Technical Service Bulletin: tsb100748

Revised Lift/Priming Pump

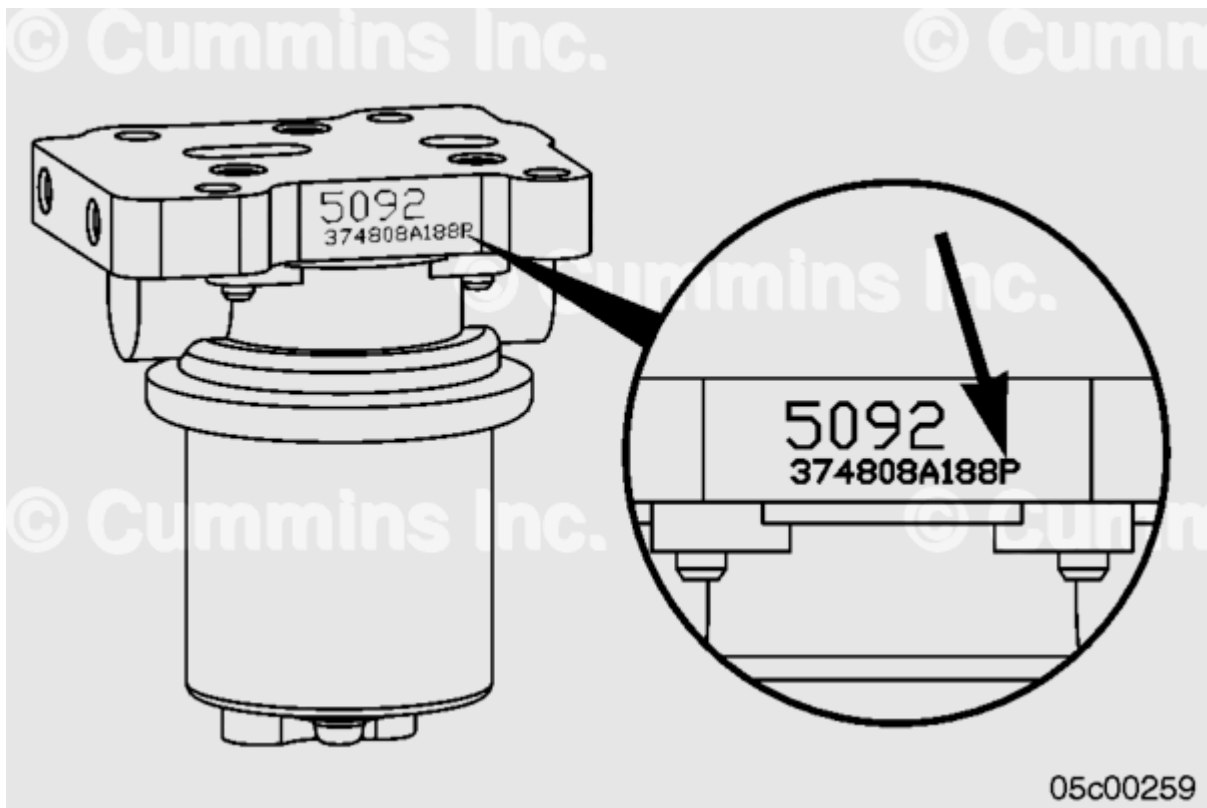
This Technical Service Bulletin introduces a revised Signature™, ISX, and QSX15 lift/priming pump and supersedes SPT 06T5-18.

The lift/priming pump used on all Signature™, ISX, and QSX15 engines has been updated. The gaskets, part numbers, and procedures no longer apply to ISX lift/priming pumps. Present production and service lift/priming pumps contain a number of revisions to improve quality and durability. The supply and discharge port locations have been changed. The gasket material has been updated to a more robust material and self-tapping capscrews are used to mount the pump to the support. These changes were made to reduce fuel leakage. In addition, a material change has been made to the insert that joins the impeller of the pump to the armature of the electric motor. This change was made to eliminate no start, low, and no lift/priming pump pressure conditions. Revised lift/priming pumps can be identified by the letter P at the end of the part number on the mounting support. See the illustration below. Present lift/priming pump part numbers and a cross reference can be found in SPT 08T5-13, ISX Transfer Pump Obsolete without Supersession.

The release date for the revised lift/priming pump for production is 17 January 2008.

The release date for the revised lift/priming pump for service is 17 January 2008.

The engine serial number (ESN) first is 79290014.
